SUBJECT: NEW RIFLE, COLORADO, PROCESSING SITE – REQUEST FOR
ADDITIONAL INFORMATION RE: DRAFT GROUNDWATER COMPLIANCE
ACTION PLAN

REQUEST FOR ADDITIONAL INFORMATION
DRAFT GROUNDWATER COMPLIANCE ACTION PLAN
NEW RIFLE, COLORADO, PROCESSING SITE
DOCKET NO. WM-00062

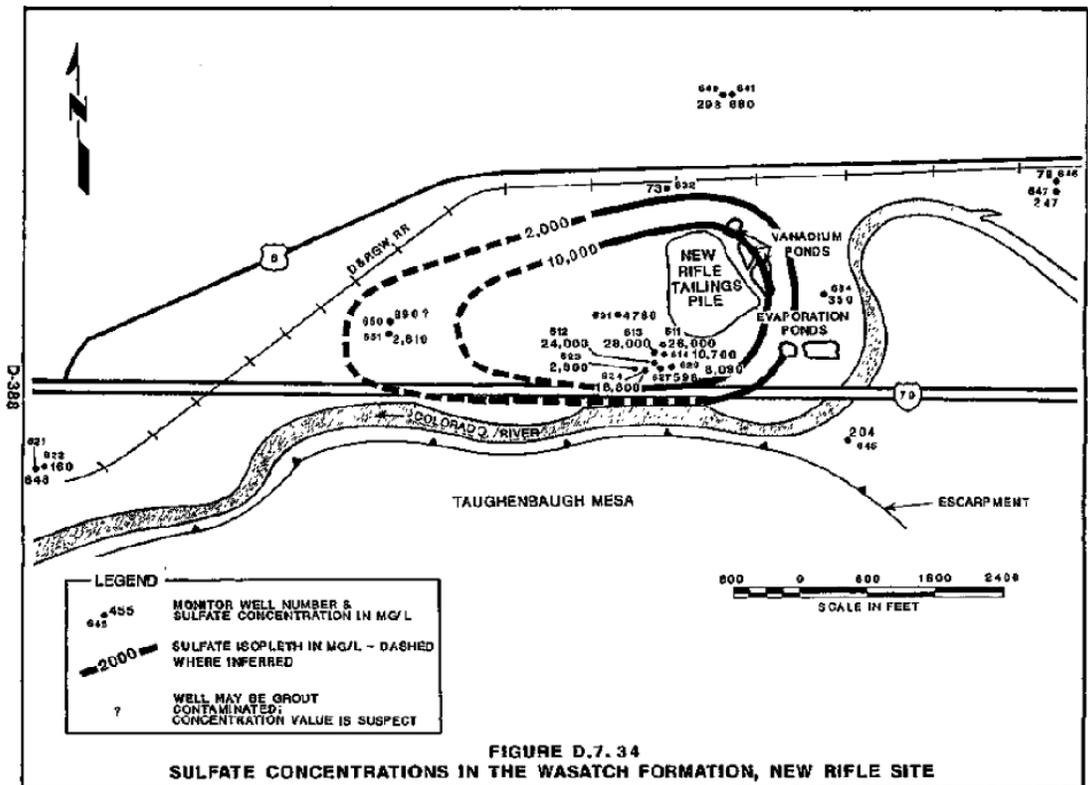
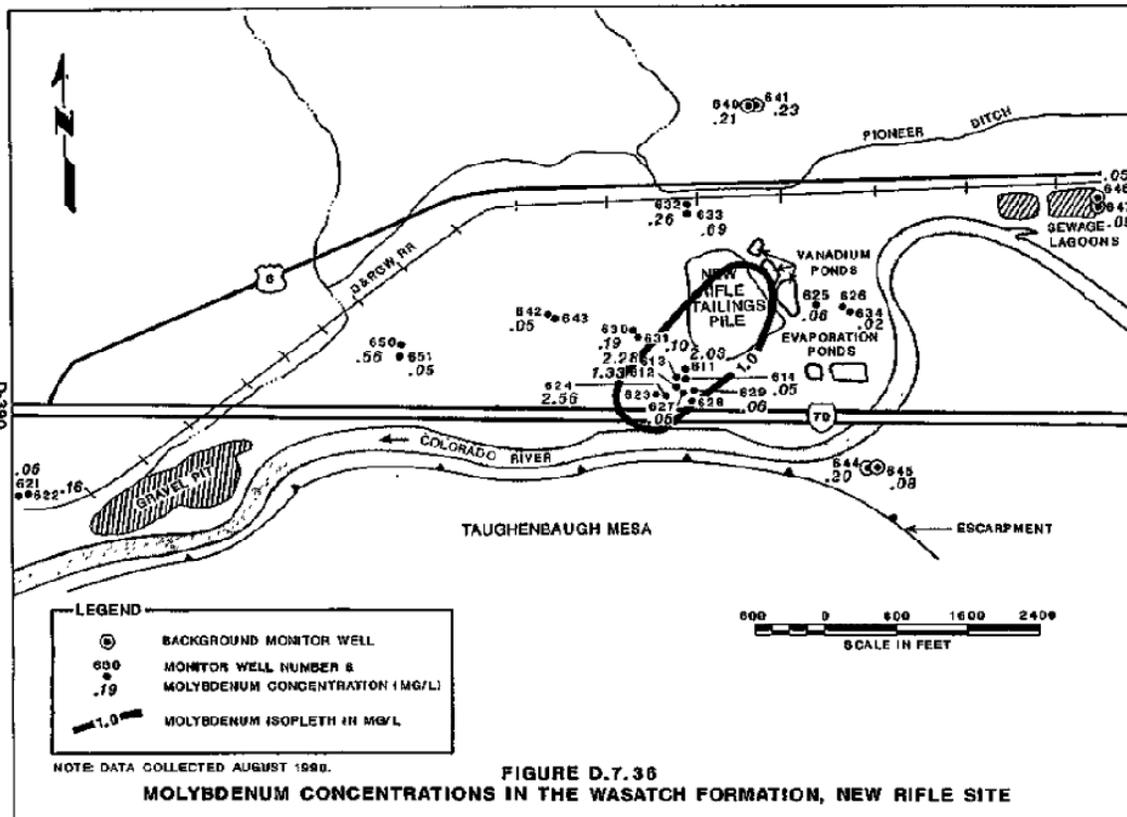
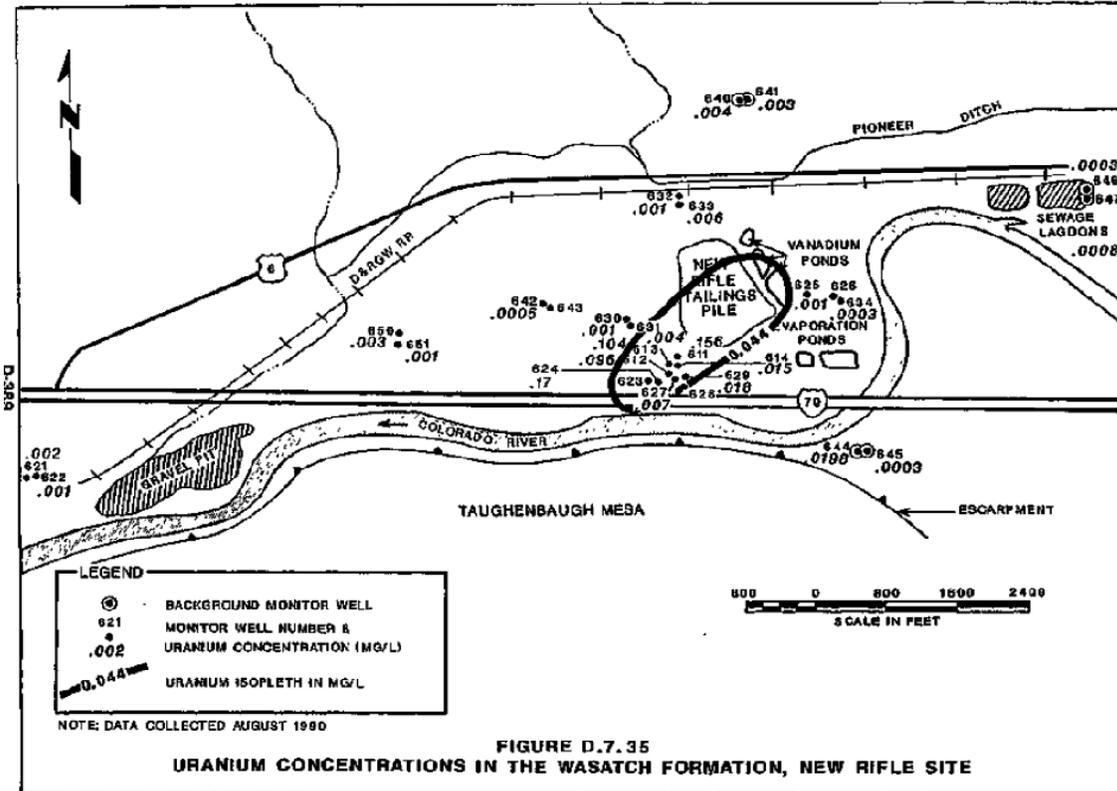
Comment 7: DOE indicated that site field investigations have shown that the alluvial aquifer is the only aquifer affected by the former milling operations (page 15). This conclusion seems to contradict previous characterization data.

Basis: Data from DOE's 1992 remedial action plan (Reference 2) shows contamination of the Wasatch formation by a variety of COC's. That document indicates that groundwater was contaminated to depths of 27 m [90 ft] and distances of 1100 m [3500 ft]. The figures below provide isopleths for sulfate, uranium, and molybdenum. In the case of uranium and molybdenum, it appears there is limited characterization data to estimate contaminant concentrations south of interstate 70 from the previous location of the tailings pile. The closest well is 0217, which showed the second highest uranium value in the alluvium [0.13 mg/L] as of November 2015 in Figure B-2 of the draft GCAP. DOE indicated that the Shire Member (uppermost layer of the Wasatch Formation) is hydraulically connected to the overlying alluvium though flow is not dominant from one unit to the other. During milling operations, very large quantities of water were used compared to the present day, which may confound the development of a conceptual model to describe the extent of groundwater contamination. High water usage may have driven contamination much deeper in the system than would be anticipated by present day hydrologic measurements.

Path Forward: Provide a description of monitoring data collected for the Shire and Molina Members of the Wasatch Formation. Reconcile the characterization data presented in the 1992 remedial action plan with the present day GCAP summary. If necessary, revise the monitoring network, and POE locations and analysis to account for contamination of the Wasatch Formation.
